Erratum for “Water Quality–Based Environmental Flow under Plausible Temperature and Pollution Scenarios

Report No: IIIT/TR/2020/-1

Erratum for “Water Quality–Based Environmental Flow under Plausible Temperature and Pollution Scenarios” by Shushobhit Chaudhary, C. T. Dhanya, Arun Kumar, and Rehana Shaik

Fig. 2. (a) Details of the Delhi segment of the Yamuna River; and (b) details of the Bhadravati segment of the Bhadra River.

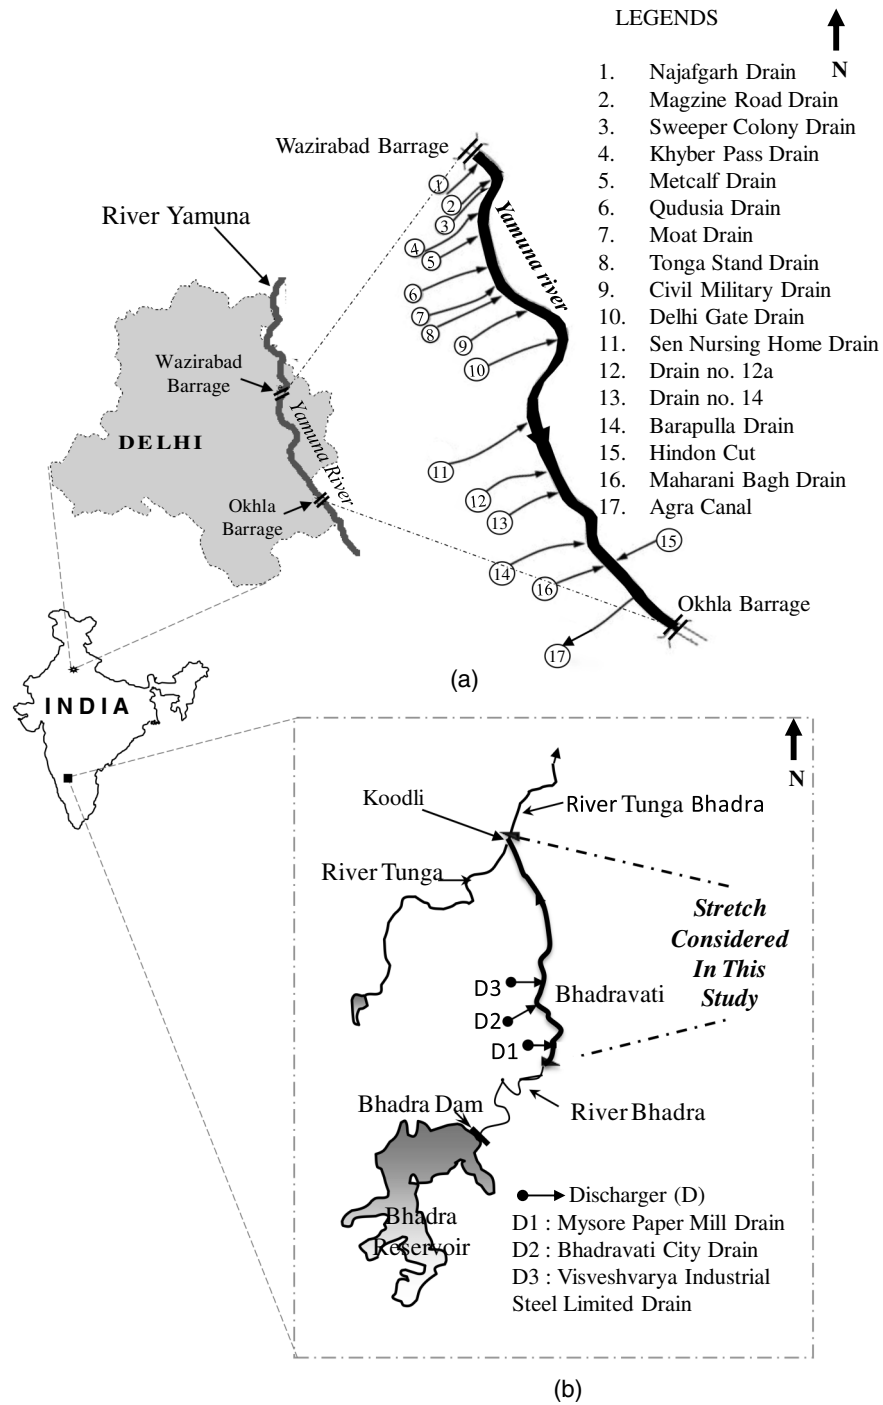
In Fig. 2(a), the labels for Drains 15 and 16 should be interchanged. The revised figure is provided herein.
